**U.S. ARMY ENGINEER DIVISION
HUNTSVILLE, ALABAMA**

**DECISION DOCUMENT FOR REMOVAL ACTIONS
AT SWMUs SEAD-11, SEAD-25, SEAD-26, SEAD-38,
SEAD-39, SEAD-40, AND SEAD-41, SENECA ARMY
DEPOT ACTIVITY**

AUGUST 1995

COMMENTS AND RECOMMENDATIONS
PRE-DRAFT DECISION DOCUMENT FOR REMOVAL ACTION AT SWMU'S
SEAD-11, SEAD-25, SEAD-26, SEAD-38,
SEAD-39, SEAD-40, AND SEAD-41
SENECA ARMY DEPOT ACTIVITY
ROMULUS, NY
JANUARY 1995

FIGURE 1
 SITE MAP AND EXPANDED SITE
 INSPECTION SAMPLE LOCATIONS

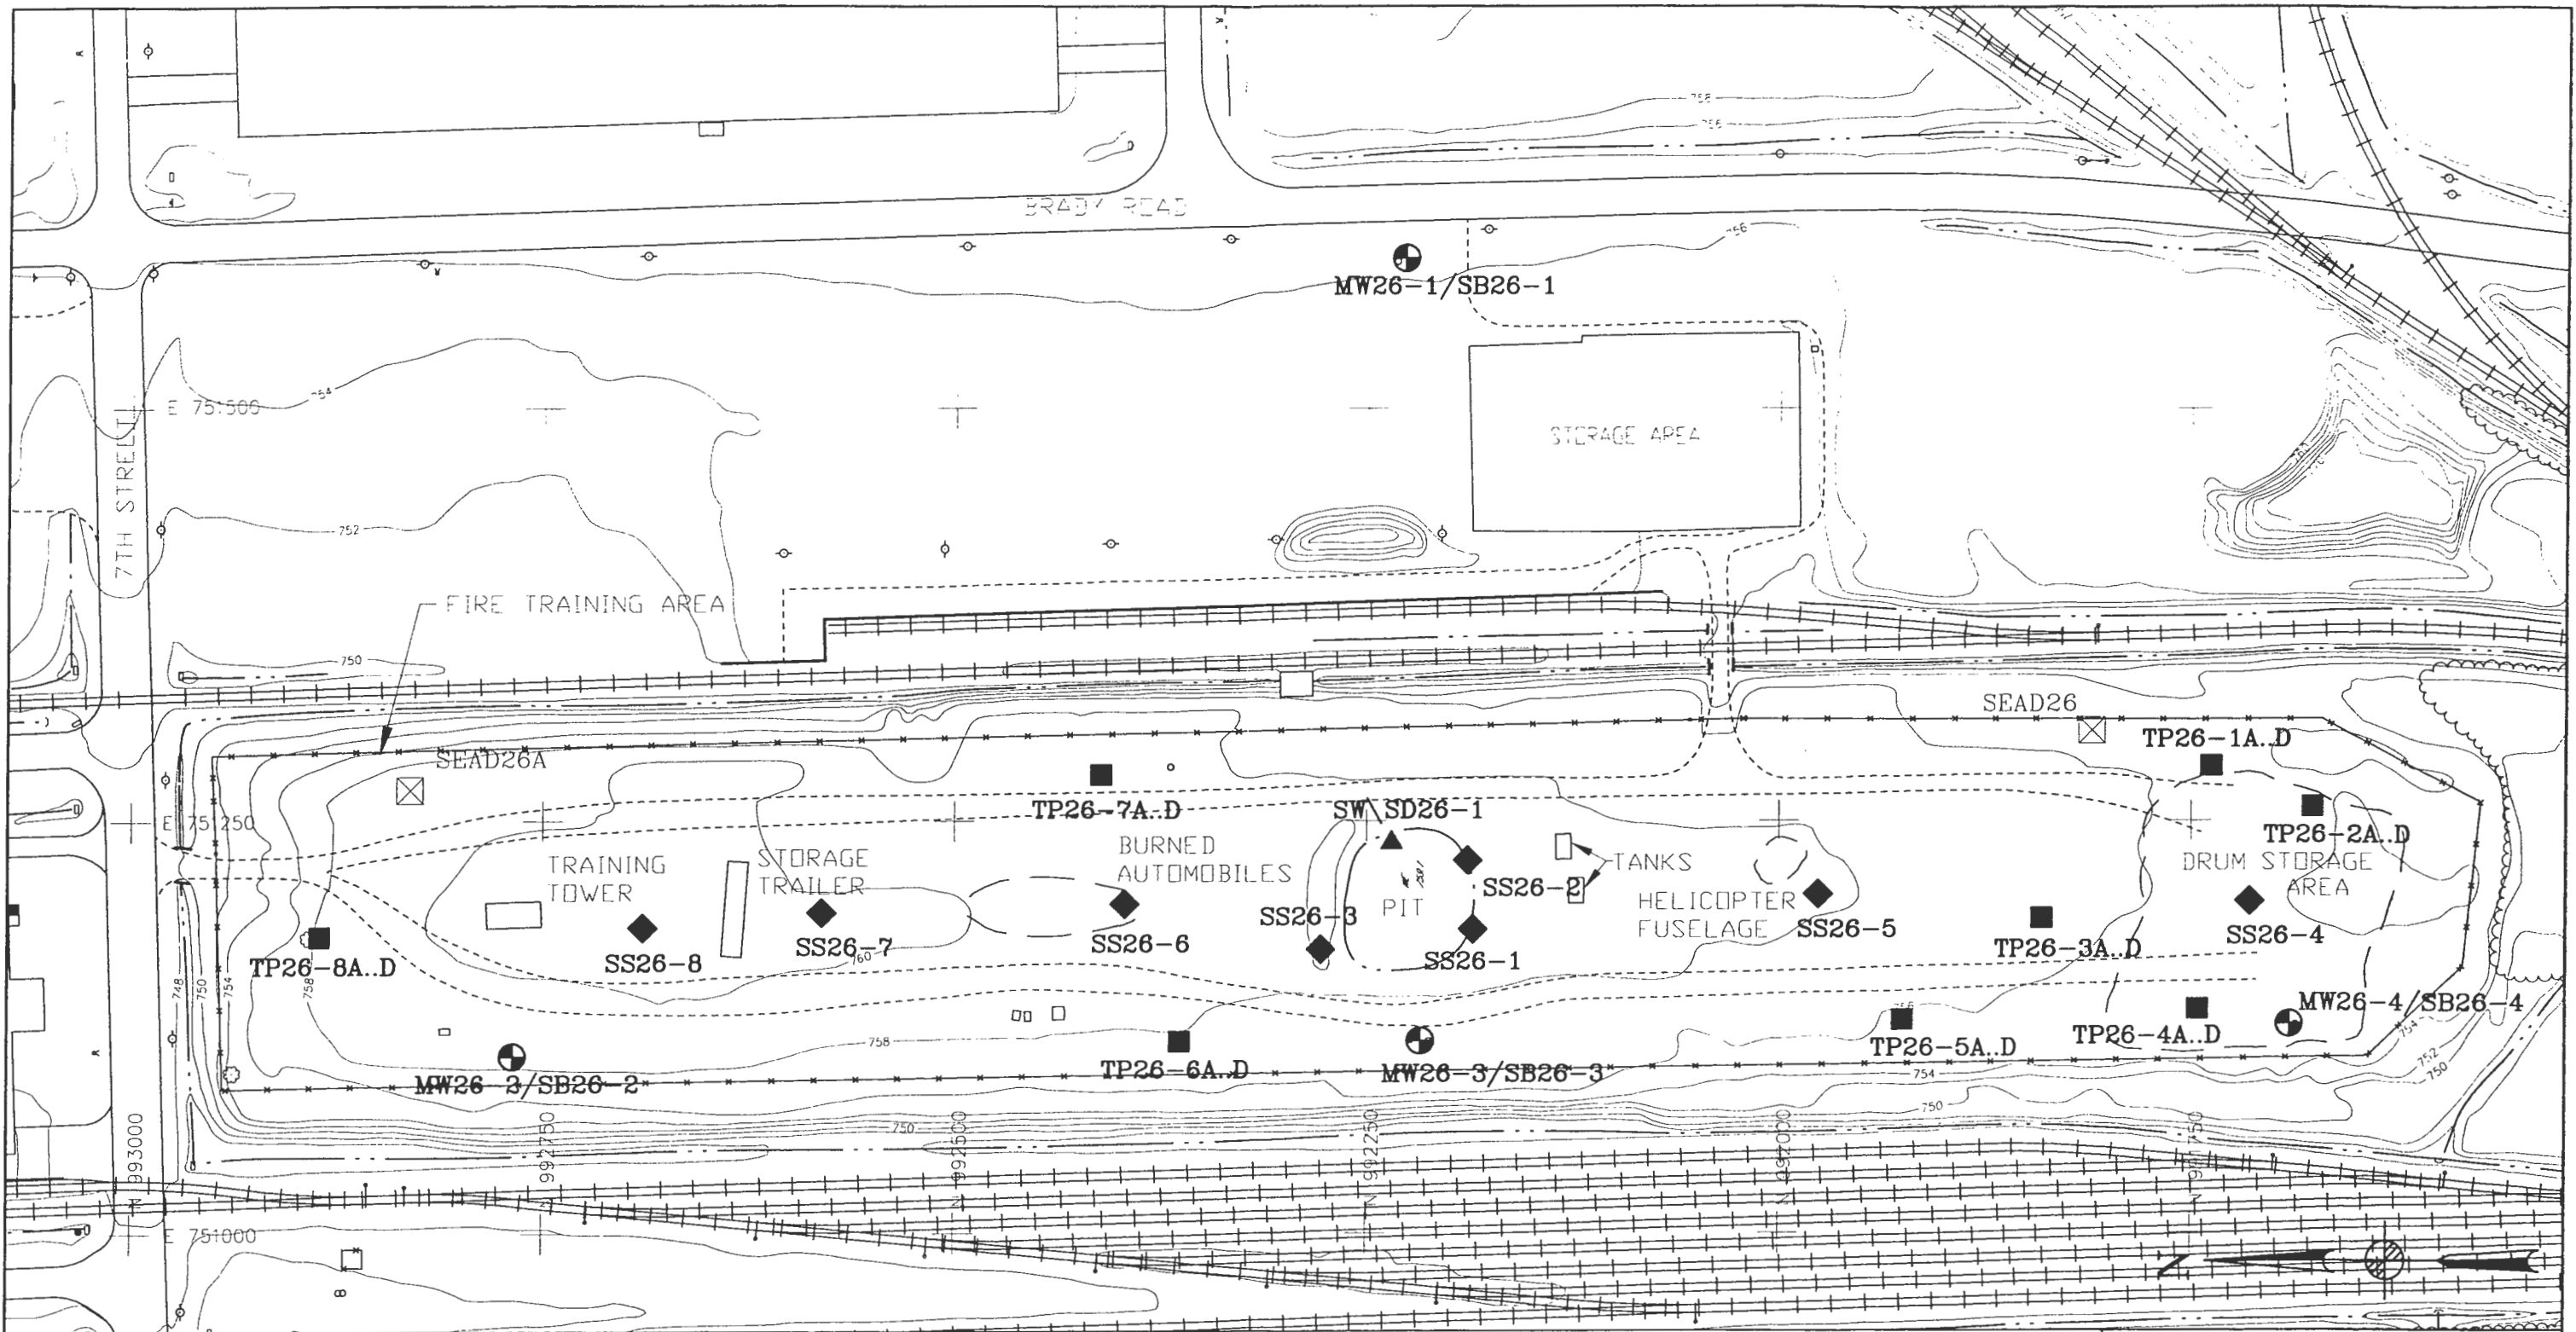
Comment #2 Page 3-1, Section 3.2.1, 1LT Clemens - Site Description.

Condition of 24 tanks removed from the site in October 1994 is not stated, and their location is not shown in any map of the site.

Recommendation: State condition of 24 tanks removed from the site in October 1994, and show their location on the site maps.

Comment #3

Page 3-6, Section 3.5, 1LT Clemens - Recommendations.

It is unclear in the RI/FS and other documents related to SEAD-26 if the underground storage tank area will be investigated further.

Recommendation: Show location of USTs on site and sample maps. Discuss approach for determining extent of any potential releases from the USTs.

Response #2 Agree. While the exact location of each of the 24 tanks removed from SEAD-26 is unknown, they were stored in the southern region of the site shown on the site map (Figure 1) as the drum storage area.

Tanks were removed from various areas within SEDA and brought to SEAD-26 because they either failed a leakage test or were scheduled for removal through SEDA's tank upgrade program. The condition of the tanks probably ranged from intact to poor. The tanks were empty and unclean when they were brought to SEAD-26.

Response #3

Agree. The drum storage area as well as the remainder of SEAD-26 will be investigated further as part of a remedial investigation and feasibility study (RI/FS). The details of this investigation are presented in the Draft Final SEAD-25 and SEAD-26 Project Scoping Plan for performing a CERCLA Remedial Investigation/Feasibility Study (RI/FS) at the Fire Training and Demonstration Pad (SEAD-25) and Fire Training Pit and Area (SEAD-26), issued in July, 1995 by Parsons Engineering Science. Sample maps, location of the USTs, and the approach for determining the extent of potential releases are presented in the scoping plan.

**FIGURE 1
 SAMPLE LOCATIONS AND
 APPROXIMATE AREA TO
 BE REMEDIATED**

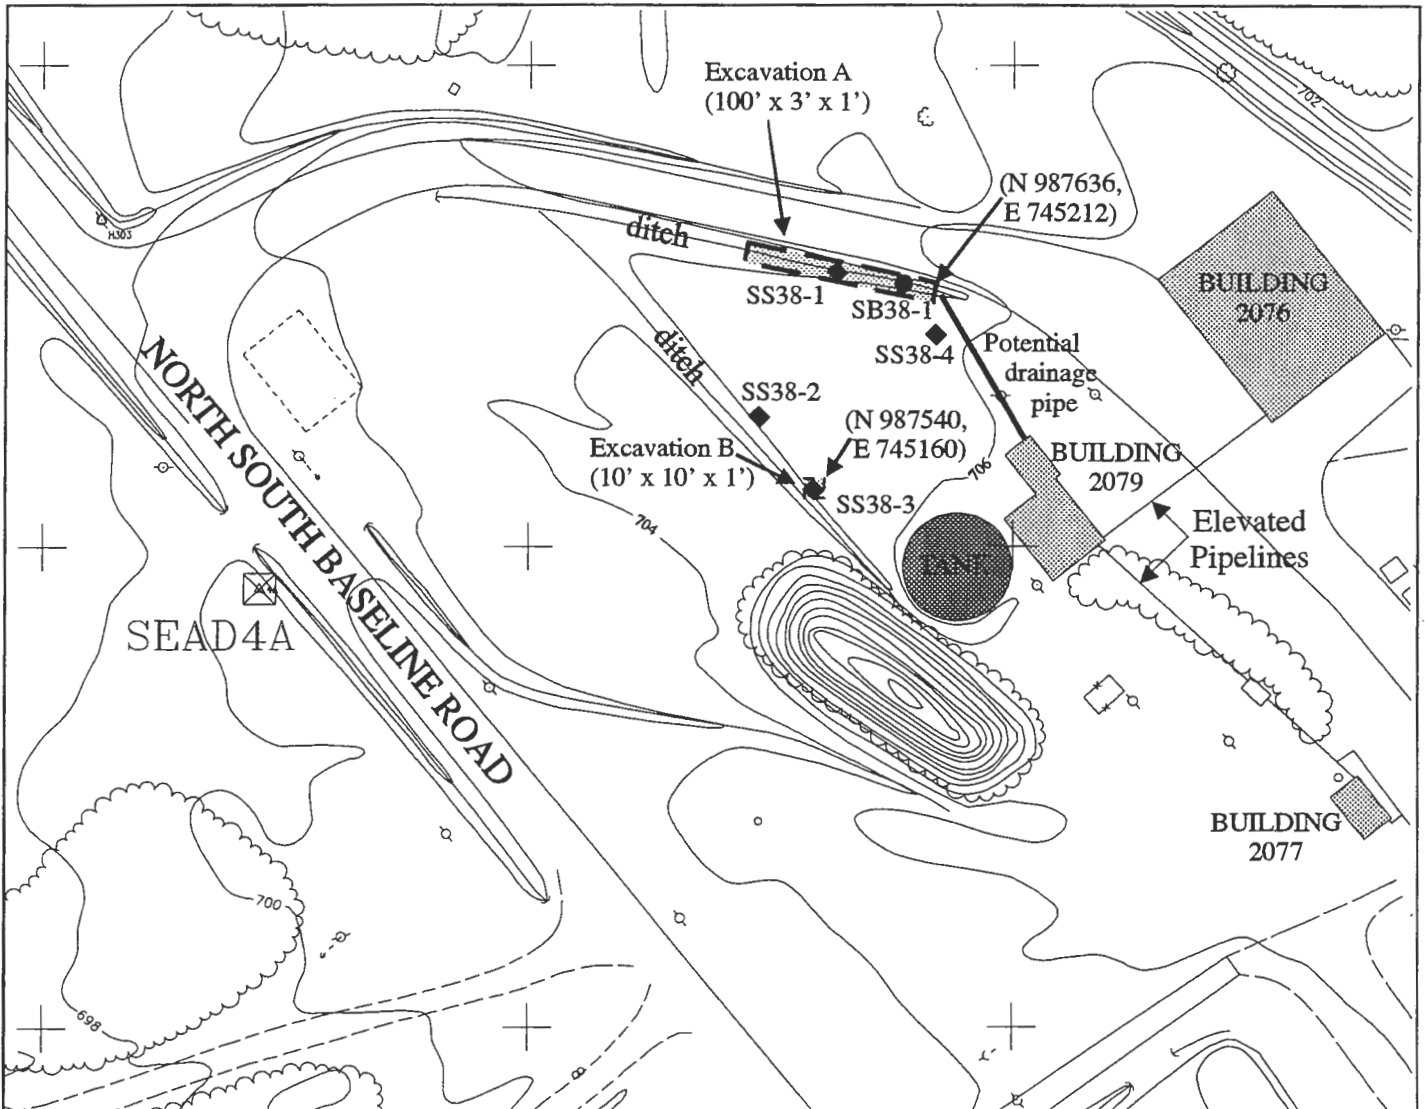
Comment #5

Page 4-1, Section 4.2.1, 1LT Clemens - Site Description.

Details discussed in text do not appear on site crude map.

Recommendation: Redraft site map at a larger scale and include details discussed in text.

Response #5

Agree. Figure 1 in Section 4 has been modified to better reflect the written description in Section 4.2.1.

FIGURE 1
**SAMPLE LOCATIONS AND
 APPROXIMATE AREA TO
 BE REMEDIATED**

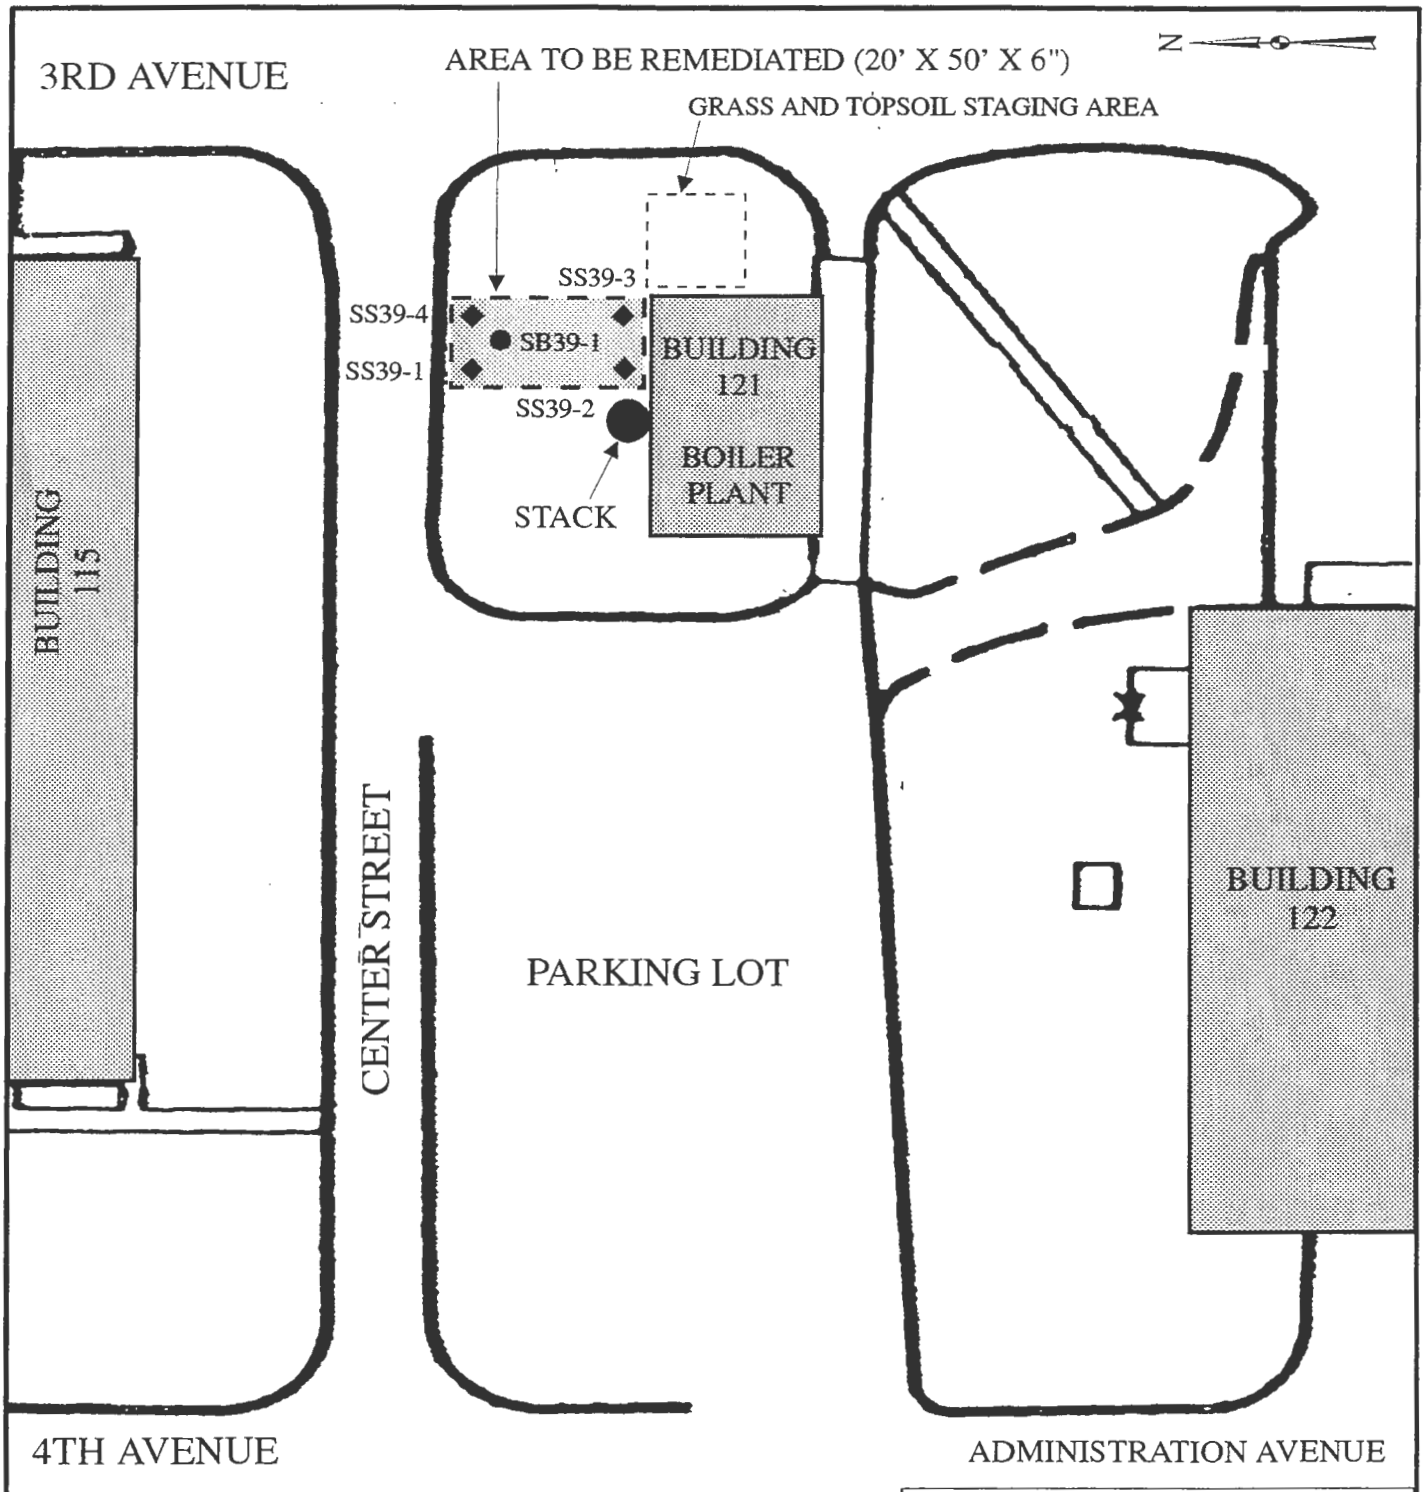
Comment #8

Page 5-1, Section 5.2.1, 1LT Clemens - Site Description.

Response #8

Agree. Figure 1 in Section 5 has been modified to better reflect the written description in Section 5.2.1.

FIGURE 1
SAMPLE LOCATIONS AND
APPROXIMATE AREA TO
BE REMEDIATED

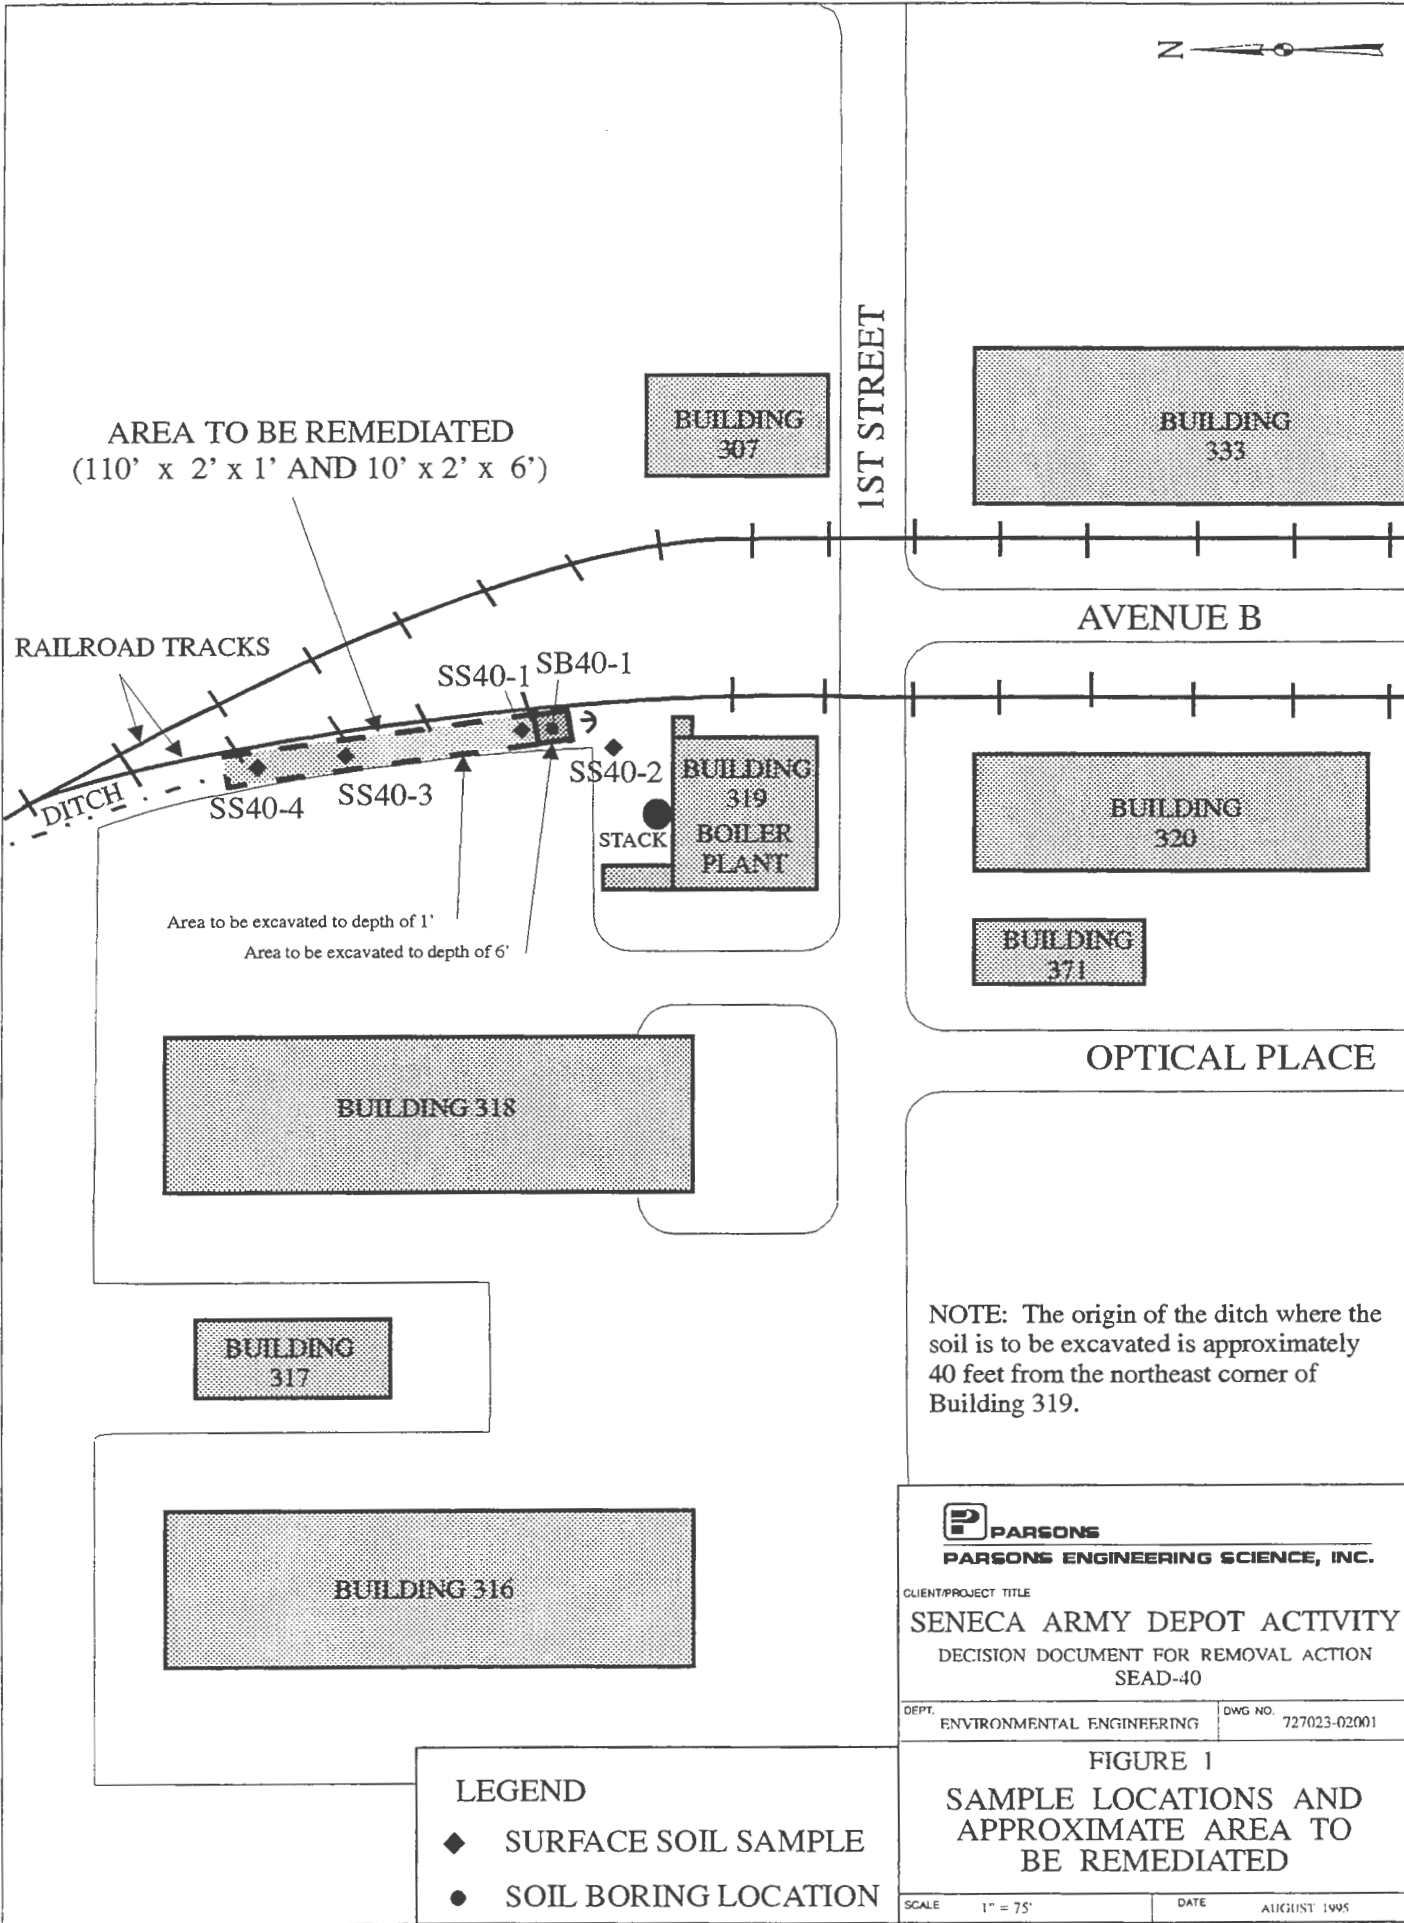
- Comment #11** Page 6-1, Section 6.2.1, 1LT Clemens - Site Description.
- Details discussed in text do not appear on-site crude map.
- Recommendation: Redraft site map at a larger scale and include details discussed in text.

- Response #11** Agree. Figure 1 in Section 6 has been modified to better reflect the written description in Section 6.2.1.
- Comment #12** Page 6-1, Section 6.2.2, 1LT Clemens - Site History.
